Groundwater Circulation Well (GCW) Technology Evaluation at the Massachusetts Military Reservation (MMR), Cape Cod, Massachusetts

June 1997

Parsons Engineering Science, Inc.

This report was prepared under the direction and coordination of James R. Gonzales of the Technology Transfer Division, Air Force Center for Environmental Excellence (AFCEE). The expert panel convened on May 19, 1997, and concluded on May 22, 1997. Presentations were made by the AFCEE Contractor (Jacobs Engineering Group), and the two recirculating well vendors (SBP Technologies/IEG-UVB Systems and Metcalf & Eddy Inc./EG&G Environmental-NoVOCs Systems). The expert panel was chaired by Dr. Robert Hinchee (Parsons ES) and included Dr. George Hoag (University of Connecticut), Dr. Paul Johnson (Arizona State University), Dr. Richard Johnson (Oregon Graduate Institute of Science and Technology), and Lt. Col. Ross N. Miller, Ph.D. (Hill Air Force Base, Utah). Other participants included Spence Smith (AFCEE MMR), Dr. Richard Peralta (Utah State University), Michael Duchesneau (Parsons ES), and Robert Polimeno (Parsons ES). Also in attendance during a portion of the panel discussion were Dr. Ian Osgerby (Army Corps

CONDITIONS INFLUENCING
ESTABLISHING RECIRCULATION

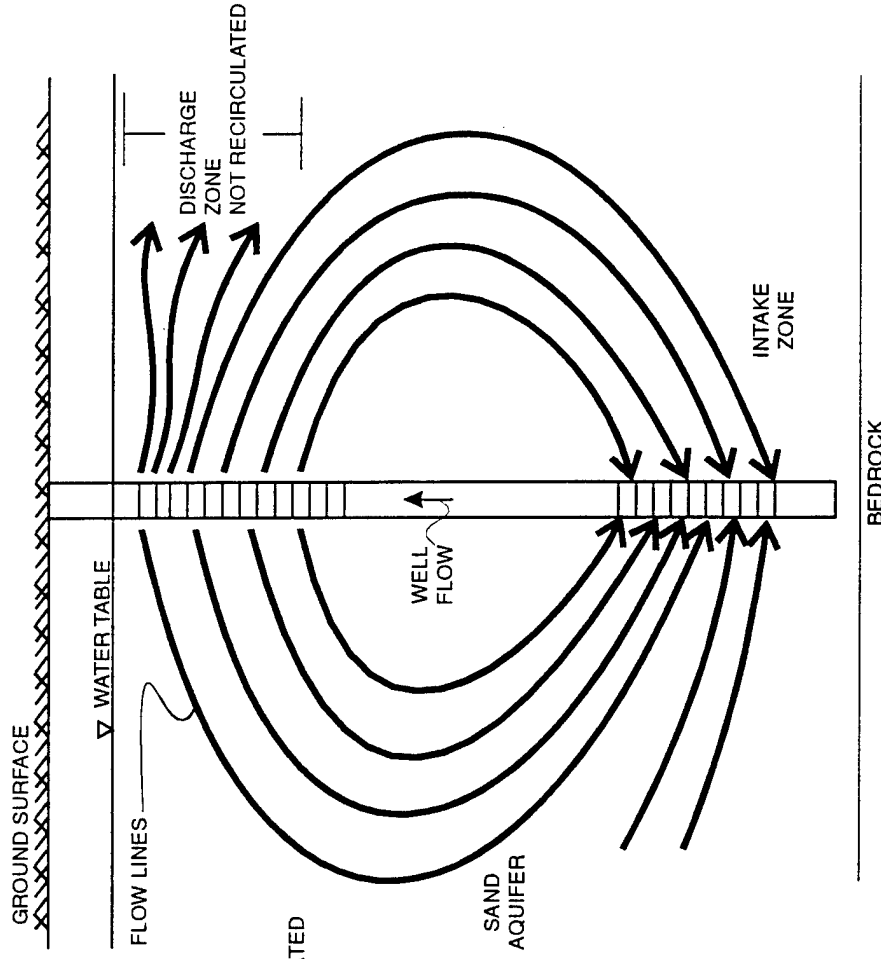
The pilot study piezometric data and the concentration changes in various wells were evaluated to determine if a circulation cell did exist. If the circulation cell did exist, then determining the extent of the circulation cell was of interest. The panel believed that neither the zone of capture nor the existence of a circulation cell could be proven with the existing data for any of the three demonstration sites. In presenting the data, both of the technology vendors believed that circulation flow was occurring, based upon the pressure data and observed changes in concentration. Groundwater modeling was used by the vendors to supplement this information and served as the basis for estimating the extent of circulation. Although the panel agreed that some of the data were consistent with development of a circulation cell, the same data were also consistent with an alternative hypothesis that no circulation cell had formed. The following figure provides an indication of the two possible occurrences. The panel agreed that if the circulation cells are closed, they very likely are not circulating at the design rate because the influent concentration appears to be on the order of twice as high as what would be expected if sufficient circulation was occurring. In order to achieve the target goal of MCLs, the system at the CS-10 location may require multiple circulation due to the low stripping efficiency. The figure provided on the following page depicts two possible cases that may be occurring at the circulation well sites at MMR. Case 1 depicts a condition where no circulation is occurring. Case 2 shows the system in operation as designed with multiple passes. With the current data, the panel could not determine which of these two cases were occurring. It is also possible that actual site conditions are somewhere in between the two cases illustrated in the figure.

If circulation is occurring, then the influent concentration of TCE at the circulation well is expected to decline over time as mass is removed. The panel considered the available data and concluded that the data did not strongly support circulation was occurring. This could be because the circulation

cells had not yet closed, but will eventually close. However, it is also possible that the circulation cells do not exist.
